TECHNICAL SERVICE BULLETIN

NO. 181-001

AFFECTS: XL-12, SXL-A0

SUBJECT: ZAMA CARBURETOR PART NUMBER A-94953

SUBJECT: CERAMIC FUEL FILTER 96184

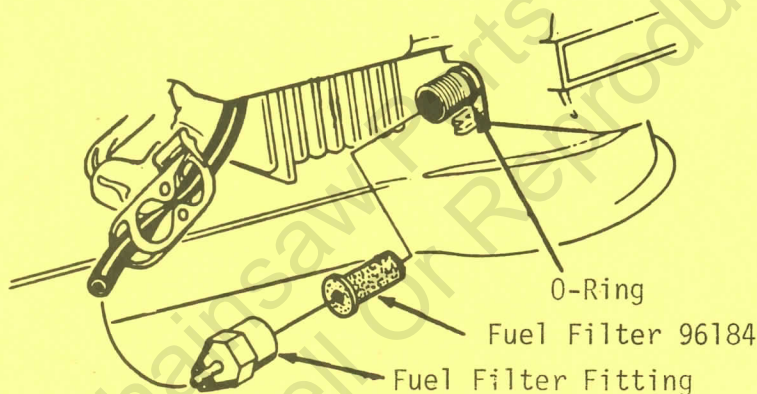
A new fuel filter 96184 made of ceramic material will supersede the felt fuel filter for the ST-80 and ST-100 string trimmers. When using the ceramic filter, the fiber gasket 65144 should be removed from the fuel filter fitting and discarded.

DIAGRAM OF THE XL PRESSURE FEED CHAIN OIL SYSTEM

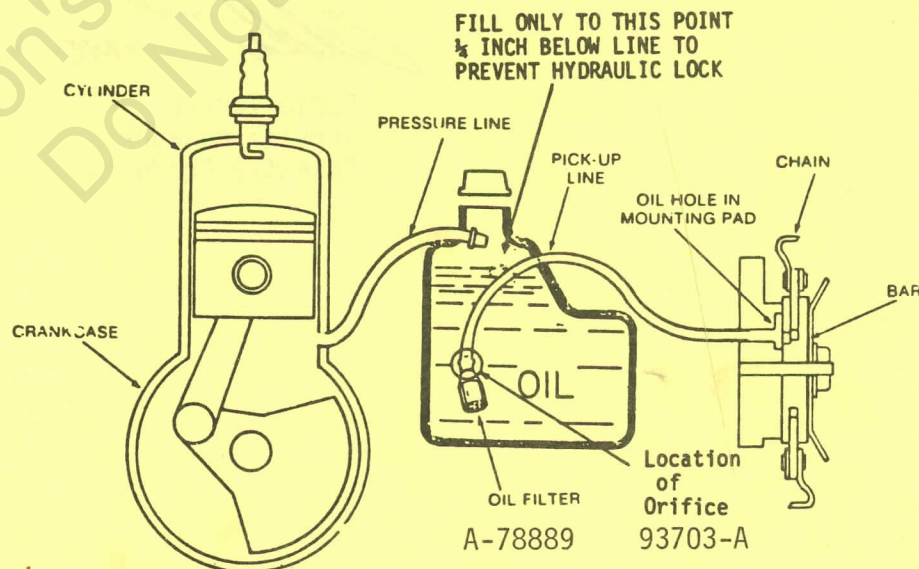
In order to service units that "siphon" oil at the guide bar pad, we are introducing a new oil filter, part number A-78889. This filter contains a check ball and spring. After two pounds of pressure builds in the oil tank the ball will open and allow oil to flow to the guide bar pad. After the unit is shutdown the pressure in the tank must "bleed off" through the powdered metal connector that holds the duck bill valve to the pressure line. Once the pressure in the tank drops below 2 PSI the valve will close. Therefore, oil cannot leak at the guide bar pad. If the connector is not porous enough to allow a rapid bleed down of pressure, the unit will continue to oil after shutdown until the pressure drops below 2 PSI. This filter is a service item only at this time. When replacing the standard filter (A-68593) with this new filter, be sure to install the orifice (93703-A) into the new filter. This orifice is standard equipment on all XL's with the pressure oil system.

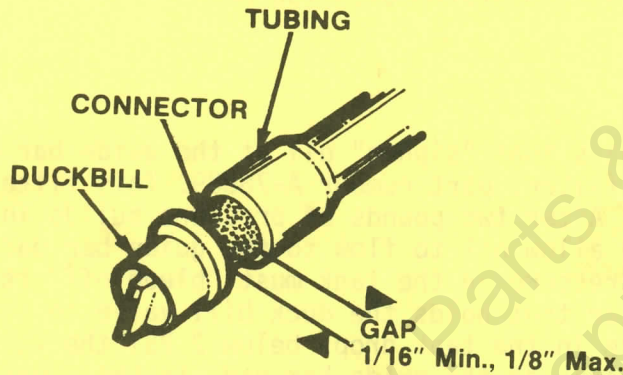
As mentioned in subject number 1, if the connector that holds the duck bill to the pressure line is not porous enough, too much pressure will build in the tank and therefore too much oil will be forced to the guide bar pad. If a unit over oils it will be necessary to install a new connector (69659-B). This new connector will allow the proper amount of pressure to bleed off while the unit is running and after it is shutdown. These new connectors will be made of stainless steel. The old connectors (69659-1A) were made of bronze. Therefore, they may be recognized by color as well as part number. Install the new connector in the location shown in the picture below.

After installing the connector, leave a gap between the duck bill valve and the tubing as indicated in the drawing above. All XL's with lot number X0340XXXX and above have connector 69659-B in the pressure line.

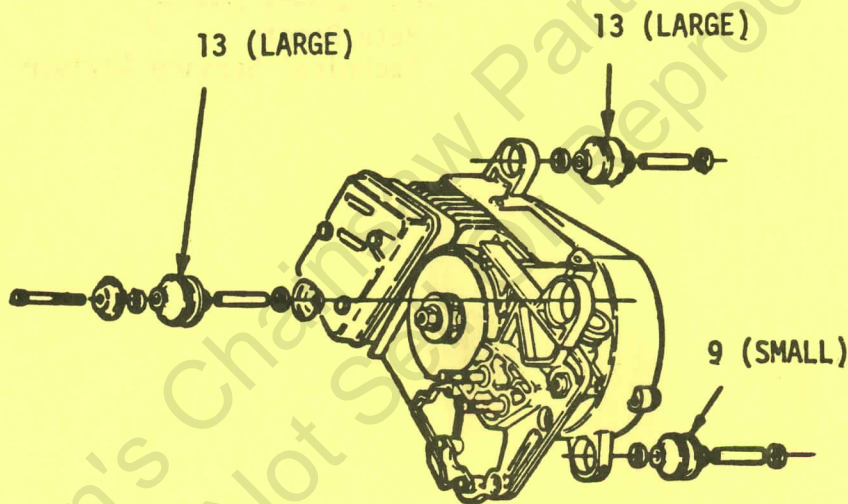
- 1) The isolator item numbers shown in the model 330 parts list (figure 2) are incorrect. Adjust your parts list according to the illustration below.

Also, figure four shows item 15 as rod bearing part number 68512. The correct part number is 93369.

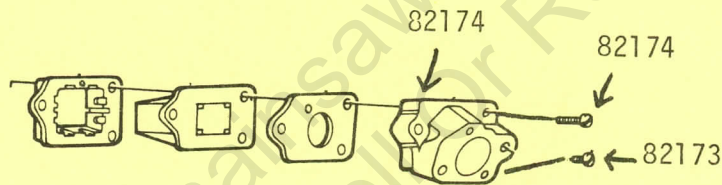
The three manifold retaining screws #82196 (1 1/8" long) have been replaced by two screws #82174 (1 1/4" long) and one screw #82173 (1" long). See the illustration below for the location of the new screws.

Should measure
 $1 \frac{5}{32}$ " in length.

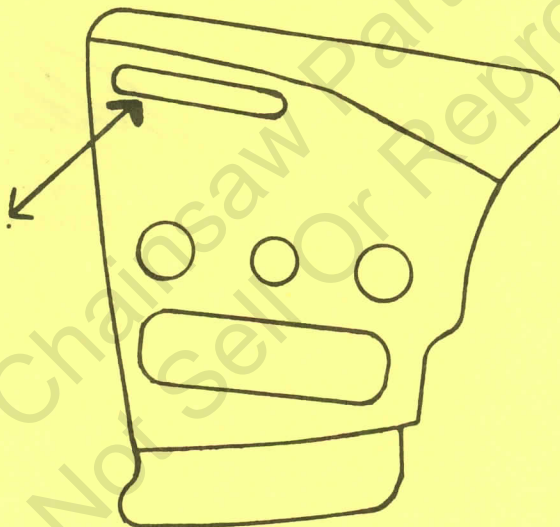
Some inner guide bar plates 56956-A were made with oil slots that are too long. The oil slot measures $1 \frac{5}{16}$ " in length. The correct length is $1 \frac{5}{32}$ ". (See Sketch).

If the plate with the longer slot is used, not all of the oil will reach the guide bar. The longer slot allows the oil to leak between the guide bar and the drivecase pad.

Drill 3/16"
(.1875) hole.

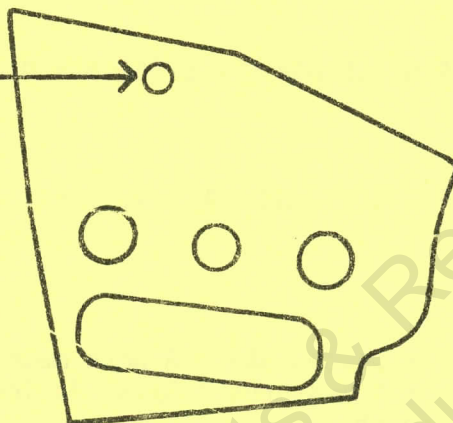
Modify an outer plate 56957-B to be used behind the inner plate. To do this cut the "fins" off of the outer plate. Place the modified plate behind the inner plate and mark the oil slot area.

Close to the center of this area drill a 3/16" (.1875) hole. (See Sketch).
Install the modified plate onto the pad and then install the inner plate.
This modified plate will close up any gap that would have been made by
the inner plate.

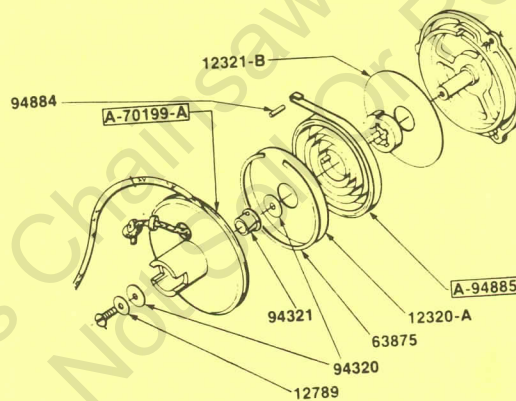
The rewind starter assemblies for the above mentioned models have been changed to eliminate the two pulley post bushings. Now only one larger bushing is used.

The illustration below details the new design and gives the new part numbers.

FIGURE #2

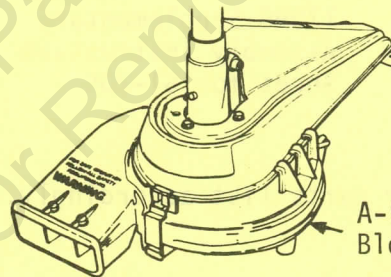
Starting with serial number 510470157, the ST-200 string trimmer will be produced with a new lower head assembly A-95800-B and a new string head cover A-94473-A. This new cover is designed for use with the ST-100 blower attachment A-93597 and can be identified by a notch in the front of the cover (See figure 1).

To retro-fit an ST-200 produced before the above mentioned serial number, it is necessary to replace the present A-94473 string head cover with the new A-94473-A cover (notched as shown above) before the blower attachment can be assembled. (See figure 2).

FIGURE #3

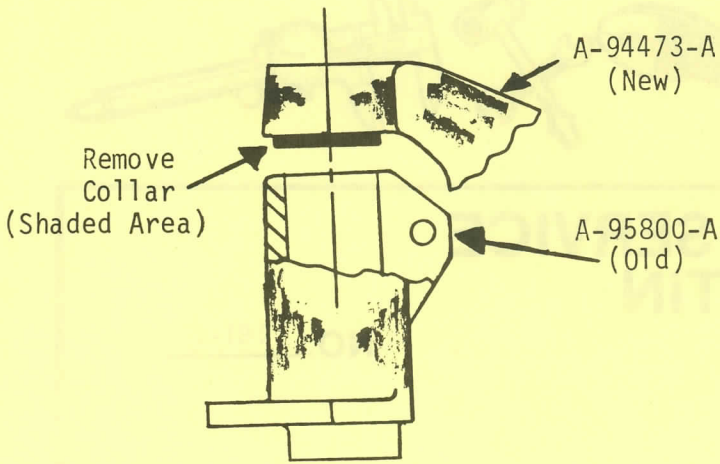
When retro-fitting the new string head cover to the old lower head assembly A-95800-A it will be necessary to remove (by filing, sawing, etc.) the locking collar as shown in figure 3. This collar on the new string head cover is used with the new lower head assembly A-95800-B which has a mating locking recess as shown in figure 4. The new head assembly can also be identified by the full length clamp.

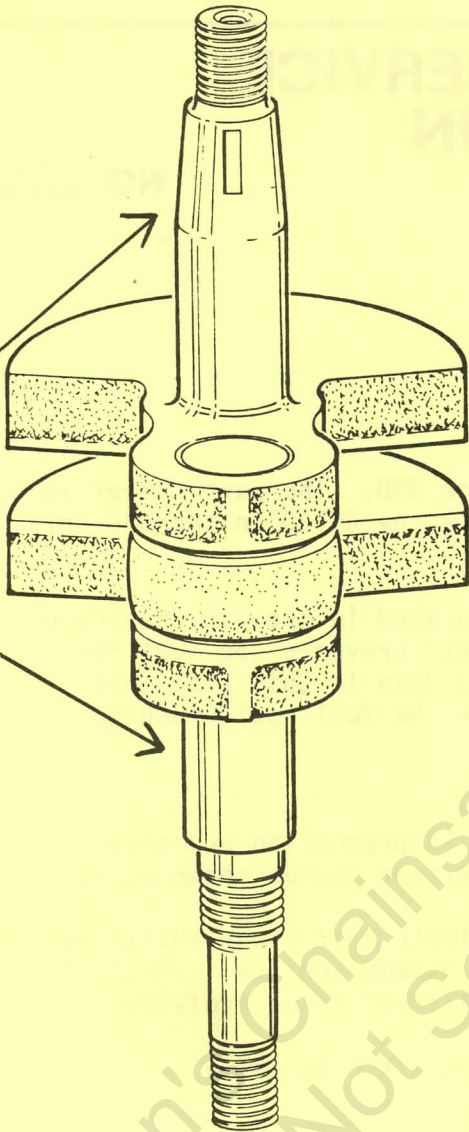
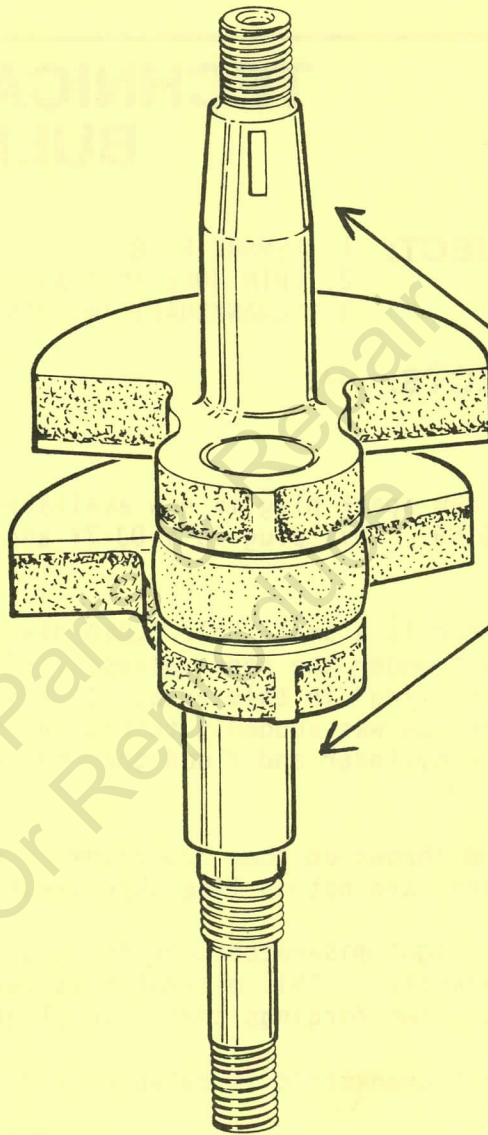
1. A new spark plug is now available for the 330. The part number is 96169. This plug is a DJ-7Y and replaced the 65130 in the 330 only.
2. There is a small hole (.040 diameter) located in the 330 crankcase, just under the reed valves. This "outlet" prevents the fuel from "puddling" in this area. If the fuel puddled in this area when the saw was suddenly turned on it's side the fuel would rush to the cylinder and flood the engine.
3. The throws on some 330 crankshafts used in production and service parts are not in line when viewed from either end as shown below.

In order to determine if the shaft is twisted, view the shaft in a vertical position as shown in the illustration on the back of this page.

Location of Rubber Tubing

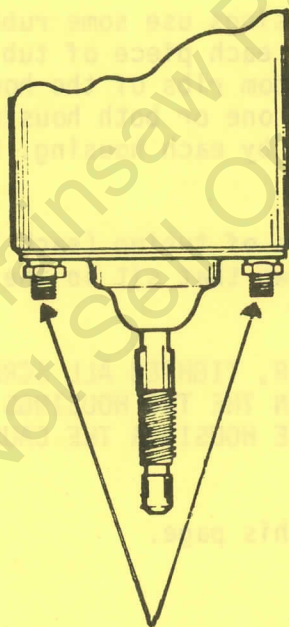
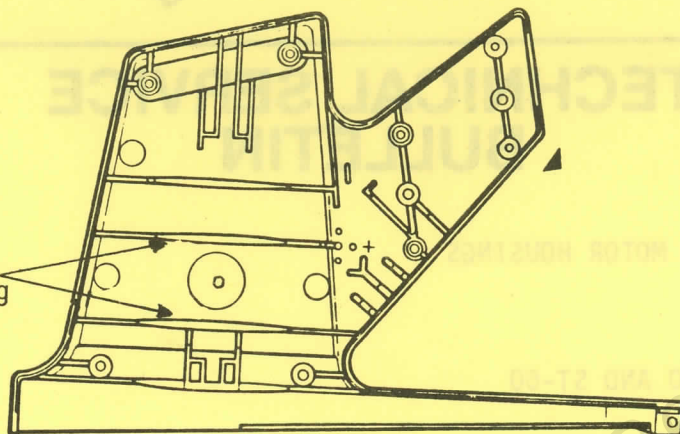
In order to repair these used housings use some rubber fuel or oil tubing cut into 3" lengths. Split each piece of tubing from end to end and place them on the two bottom ribs of the housing. Refer to illustration. This can be done to one or both housings, depending upon the amount of wear sustained by each housing. Use your own judgement in this repair.

As added insurance, cut two pieces of tubing (each 1/8" long) and place them on the end of the motor screws that sit in the housing bosses. Refer to illustration.

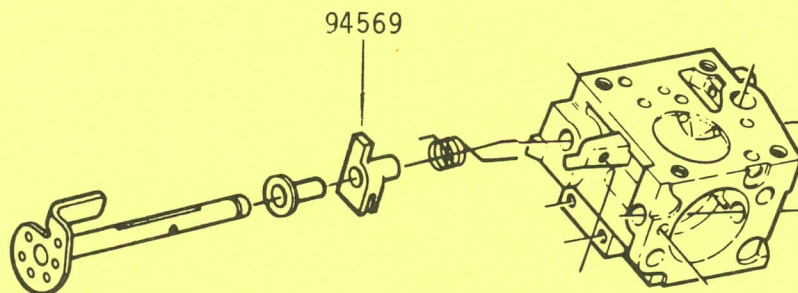
- 1) Lower head number 46785-1A is superseded by a lower head assembly kit number A-96756 on the ST-400. The left side of the clamp has been modified so that more clamping force may be applied to the shaft housing tube.

The socket head screw 80373-1 (1/4-20 x 3/4") that clamps the lower head to the tube has been replaced by a socket head screw 80428-1 (1/4-20 x 1") and lockwasher 83061. The torque specification for screw number 80428-1 is 135 inch/pounds.

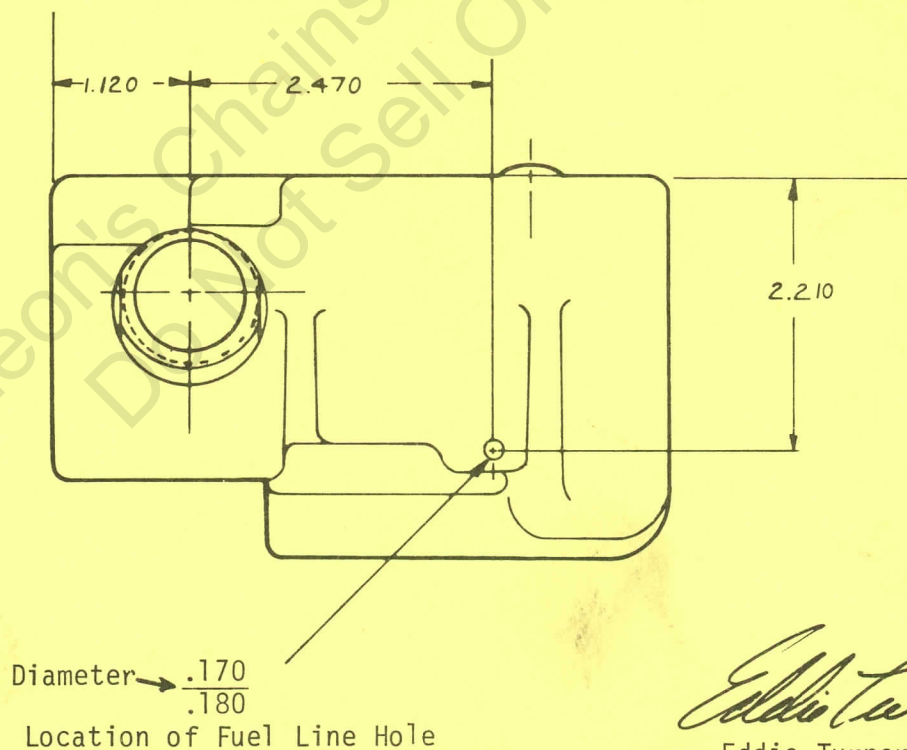
The ST-200 parts list (#17435) indicates the wrong fuel line part number. The part number shown in the list is 93157-24. The correct part number is 70310-24. The 93157-24 has a thicker wall, therefore, making it difficult to thread the line into the tank and it also restricts fuel flow. The ST-200's have been built with the 70310-24 fuel line.

Some fuel tanks 94445-1 have the hole for the fuel line drilled in the wrong location. This results in a pinched fuel line when these tanks are assembled into a unit. If a new unit starves for fuel, suspect a pinched fuel line. See the illustration below for the proper hole location. The part number has been changed to A-94462-B.

Figure #1

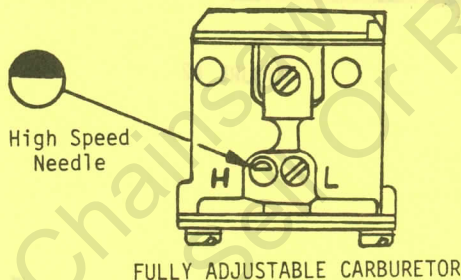
This carburetor can be identified by a short high speed needle that has a "D" shaped key instead of a screwdriver slot. (See Figure #1). To adjust this carburetor, remove the air filter cover, then use a needle nose pliers to turn the "D" shaped needle. The initial settings are 1¼ turns open for both the high and low speed needles.

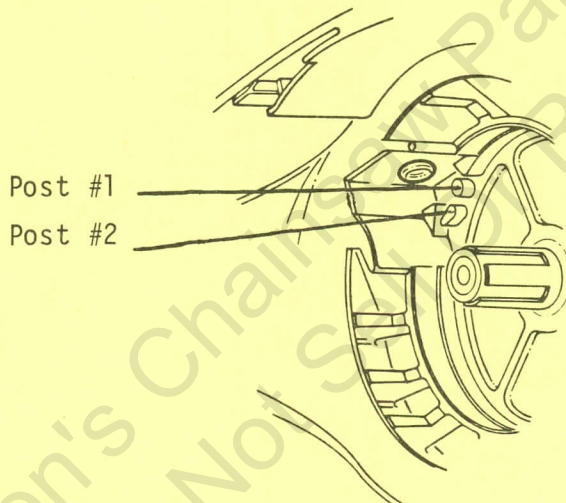
It has come to our attention that some starter housings are being replaced because of broken recoil spring posts. You will note that most housings have two posts located near the rope eyelet (see drawing). Each post is for a different type recoil spring.

The "round" post (#1) is for the recoil spring that is used in production. This spring is enclosed in a metal container. Post number 2 is for our service recoil spring, part number 69217.

If the production recoil spring post should break it is not necessary to replace the starter housing. Use recoil spring 69217 and mount it on post number 2.

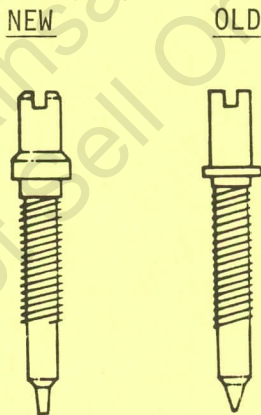
We have received complaints from the field that the 410 carburetor is difficult to adjust and that it loses its adjustment after a short period of use. These problems have been traced to the high speed needle. Due to the shape of the point on the needle the slightest movement affects carburetor adjustment.

In order to correct these problems the needle has been reshaped. This will make the carburetor easier to adjust and it will retain its initial setting longer.
